PIC32MX1XX/2XX 28/44-pin XLP Family Silicon Errata and Data Sheet Clarification

The PIC32MX1XX/2XX 28/44-pin XLP family devices that you have received conform functionally to the current Device Data Sheet (DS60001404B), except for the anomalies described in this document.

Data Sheet Clarifications

FIGURE 1:

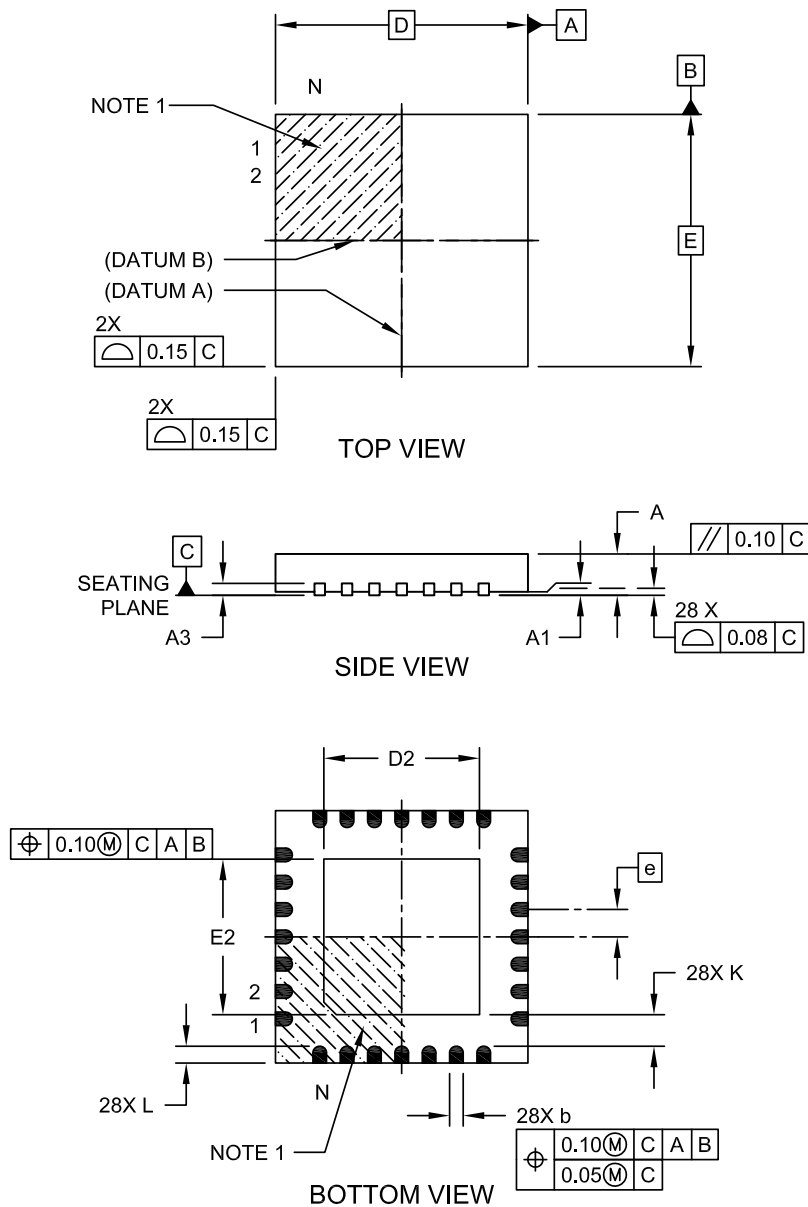
1. Module: 28-Lead QFN-S Package

In the current data sheet, incorrect packaging information was provided for the 28-Lead QFN-S package. [Figure 1](#) through [Figure 3](#) show the correct package drawings and land pattern.

28-Lead Plastic Quad Flat, No Lead Package (MM) - 6x6x0.9mm Body [QFN-S] With 0.40 mm Terminal Length
